TECHNICAL BULLETIN
Q238NAS2
18 JUN 2014

Service Action: Rear Spoiler Load Spreading Bracket

Range Rover Sport (LS)

Model Year: 2012-2013
VIN: CA717173-DA764544

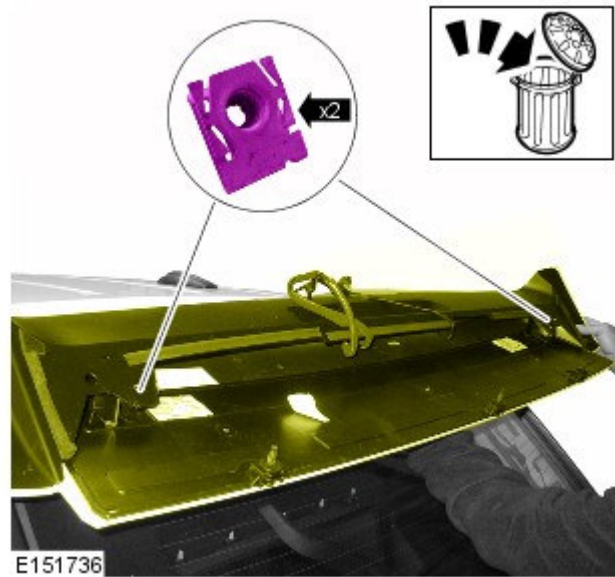
7. Remove the two (2) clips.

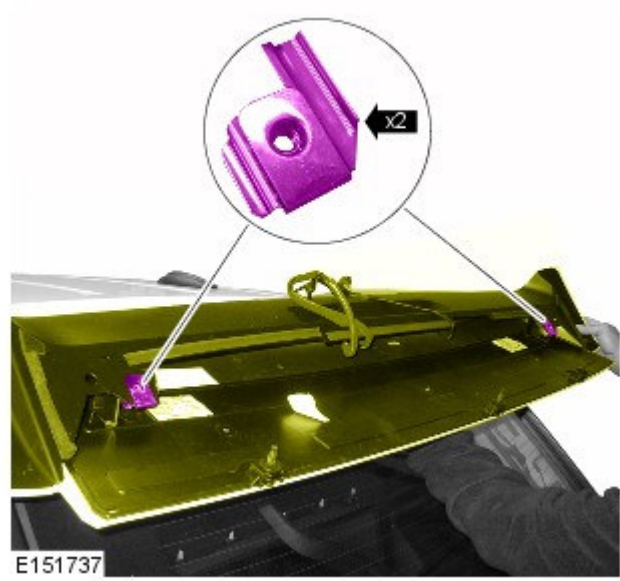
8. Install the two (2) new clips.
